# Changes to the ComEd Reactive Transfer Interface Definition

Liem Hoang  
PJM Transmission Operations  
November 2015

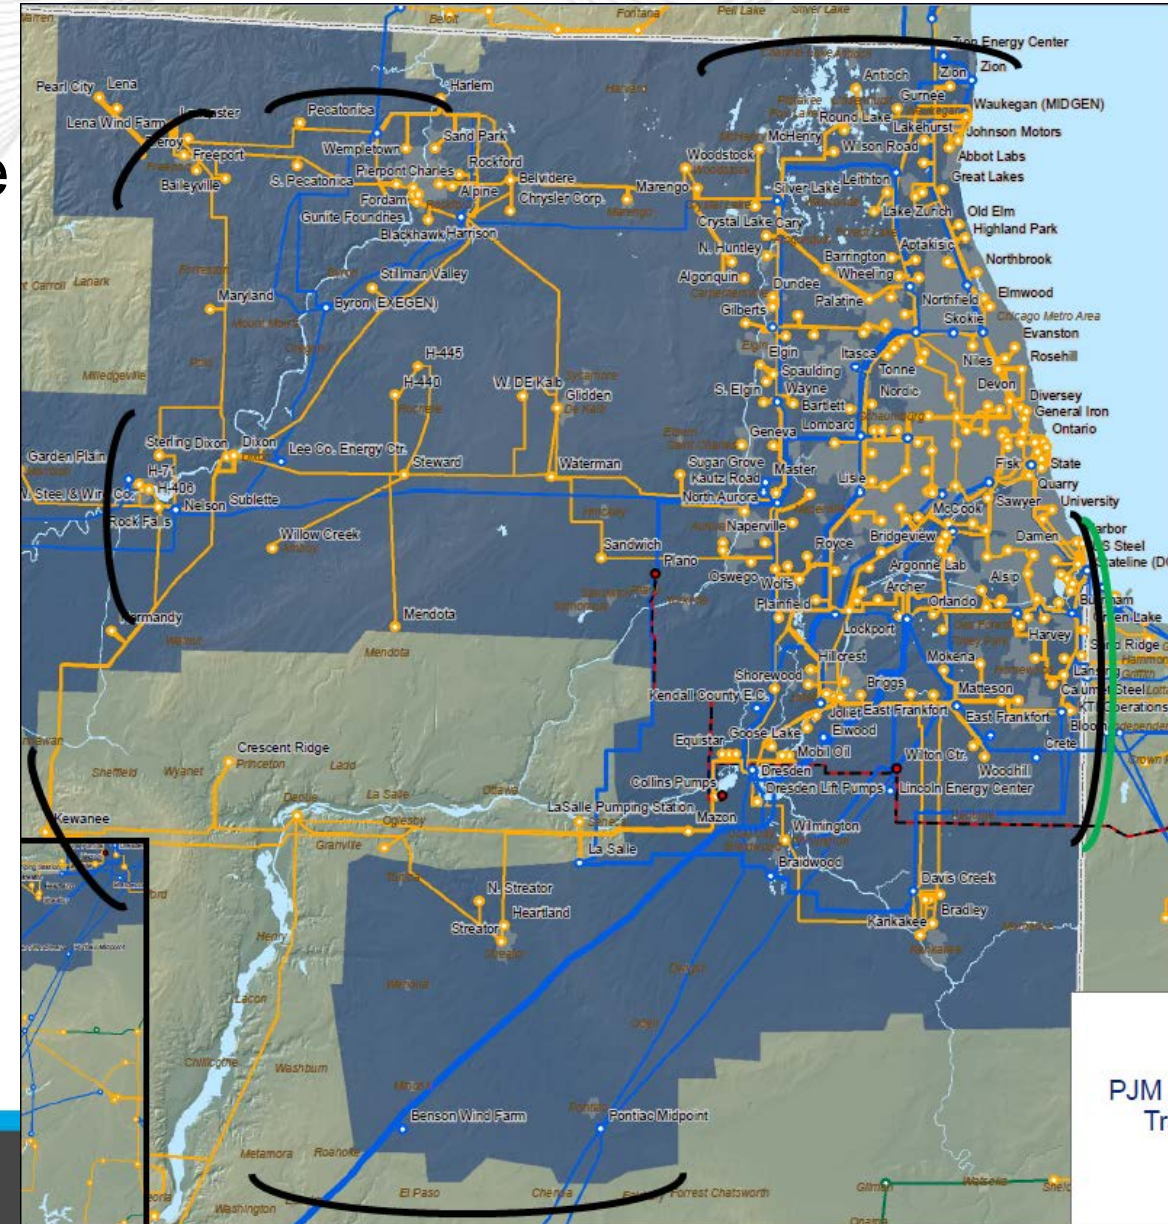
- Interface implemented in June 2013
  - Definition composed of all ComEd tie lines (closed loop)
  - Interface is used to monitor and to control for reactive issue when the zone is importing (peak summer conditions)
  - Interface has not bound in real-time
- New Interface definition will be changed to six EHV lines
  - Implementation will be made effective March 1, 2016
  - New interface will be on the ComEd eastern border
  - New interface will be named “CE-EAST”

- Reasons for change
  - Create an opened-loop interface
    - Certain generators in MISO generation can help with voltage issues in Chicago / M2M.
  - Generators near the Chicago load center should have higher raise-help dfax than units in the west and in the south.
  - Overall generation and dfax mix in the new CE-EAST interface better manage voltage issues during peak load conditions.
  - Flows increase on the eastern lines when the load is high.

- Interface Definition – “from-to” substations
  - 1) Dumont-Wilton Center 765 kV line
  - 2) Olive-University Park 345 kV line
  - 3) St. Johns-Crete 345 kV line
  - 4) Sheffield-Burnham 345 kV line
  - 5) Sheffield-Stateline 345 kV line
  - 6) Munster-Burnham 345 kV line
